February 10, 2009

SUBJECT: TECHNICAL BASIS FOR REVISED REGULATORY GUIDE 1.183
FISSION PRODUCT FUEL-TO-CLADDING GAP INVENTORY

**Proposed Revisions to Section 3.2
of Regulatory Guide 1.183**

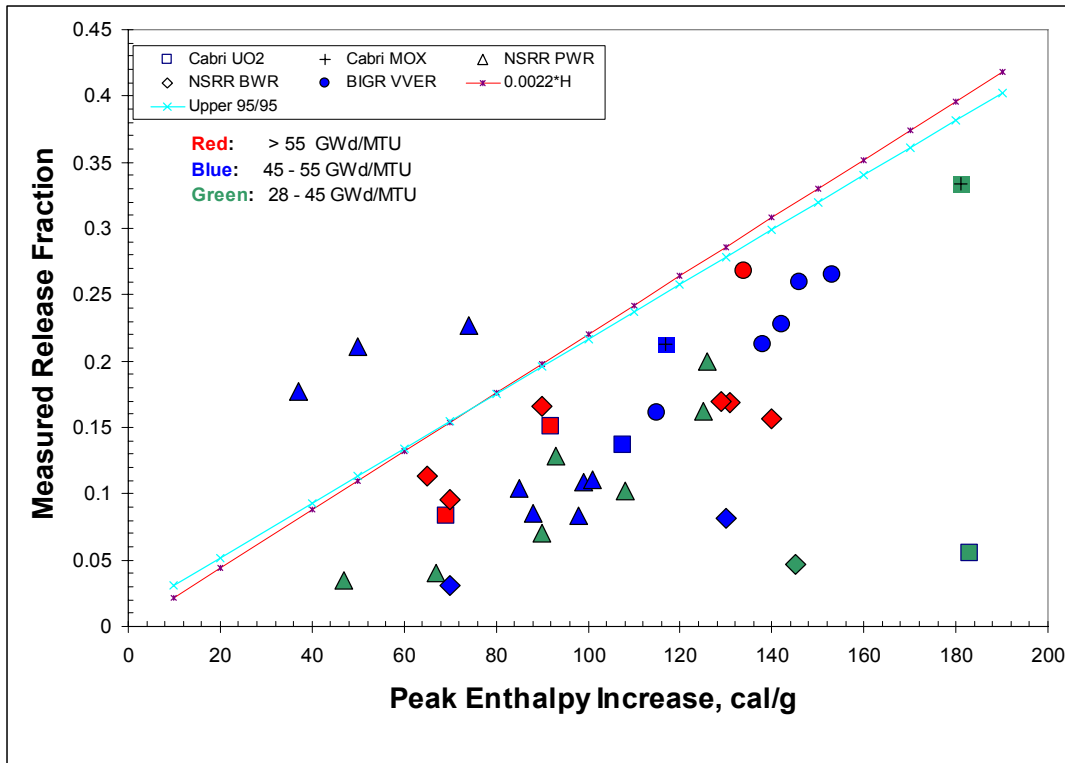
Currently, RG 1.183 Table 3 gap fractions are applicable to all BWR and PWR fuel rod designs (limited only by the footnote 11 limits). For a given power envelope, fission gas release varies significantly between fuel designs. For example, with an identical power history, the calculated gap fractions for a PWR 14x14 fuel rod would be larger than for a PWR 17x17 fuel rod. However, to maintain consistency with the current RG, the staff decided to select the maximum calculated gap fractions (rounded up to nearest 0.01) from the limiting PWR fuel rod design and

limiting BWR fuel rod design. These values are listed below along with the current Table 3 gap fractions:

The revised fission-product gap inventories are applicable to all fuel designs operating within the PWR and BWR rod power envelope depicted in Figures A-1 and A-8 in the attached PNNL technical report. It is important to note that FRAPCON-3 calculations were performed on several rods - each operating on a different segmented power history comprising the overall power envelope. This approach was selected to remove excessive conservatism. The presumption that a single fuel rod operates continuously at the peak power burnup envelope is unrealistic. The segmented power history approach maintains an adequate level of conservatism.

Group	Gap Inventory Fractions - 95/95 Upper Tolerance			Current RG 1.183 Table 3
	Calculated PWR 14x14 design	Calculated BWR 9x9 design	Maximum	
Kr-85	0.348	0.257	0.35	0.10
I-131	0.073	0.036	0.08	0.08
I-132	0.225	0.111	0.23	0.05
Other Nobles	0.031	0.016	0.04	0.05
Other Halogens	0.042	0.021	0.05	0.05
Alkali Metals	0.457	0.336	0.46	0.12

Figure 1 Maximum Allowable Power Operating Envelope for Non-LOCA Gap Fractions

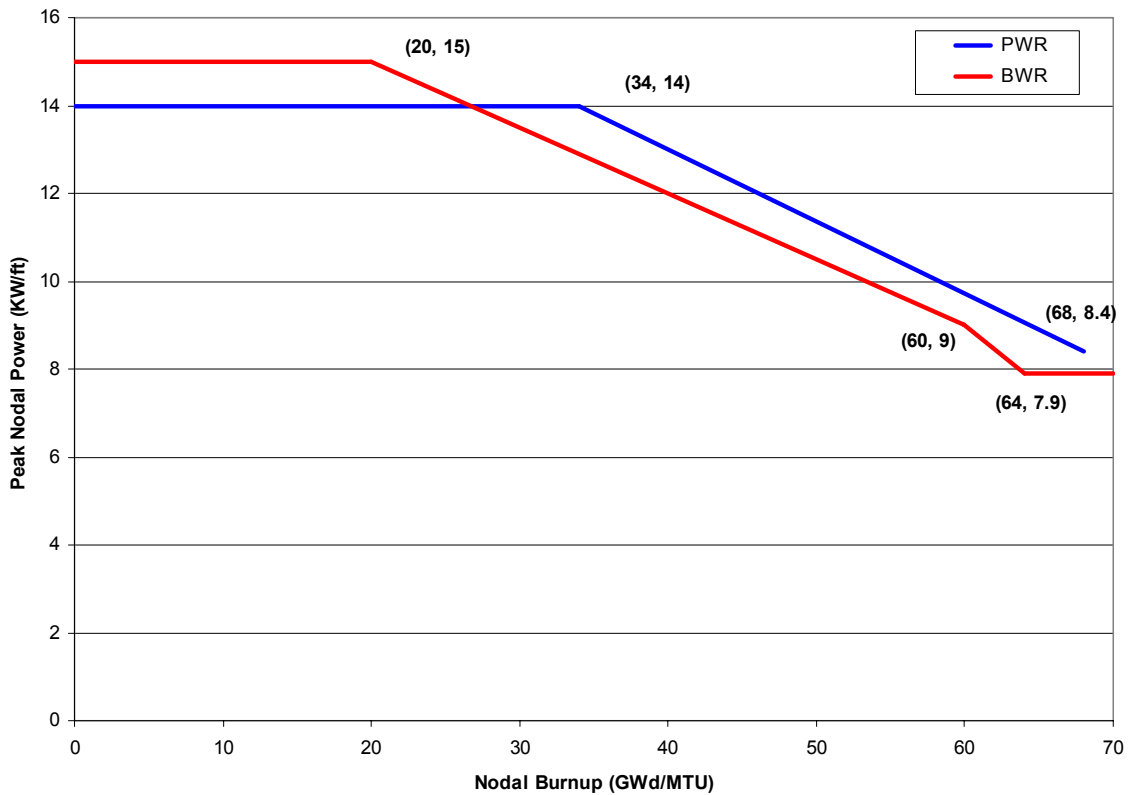
For non-LOCA DBAs, where only the cladding is postulated to be breached, Table 3 gives the fractions of the core inventory for the various radionuclides assumed to be in the gap for a fuel rod. The release fractions from Table 3 are used in conjunction with the calculated fission product inventory calculated with the maximum core radial peaking factor. The licensing basis of some facilities may include non-LOCA events that assume the release of the gap activity from the entire core (e.g., heavy load drop accident). For events involving the entire core, the core-average gap fractions of Tables 1 and 2 may be used and the radial peaking factor may be omitted.

11 The NRC has determined the release fractions listed here to be acceptable for use with currently approved LWR fuel with a peak rod average burnup up to 62,000 megawatt days per metric ton of uranium (MWD/MTU) (PWR) and a peak pellet burnup up to 70,000 MWD/MTU (BWR). The data in this section are not applicable to cores containing mixed oxide (MOX) fuel.

Group	Fraction
I-131	0.08
I-132	0.23
Kr-85	0.35
Other Noble Gasses	0.04
Other Halogens	0.05
Alkali Metals	0.46
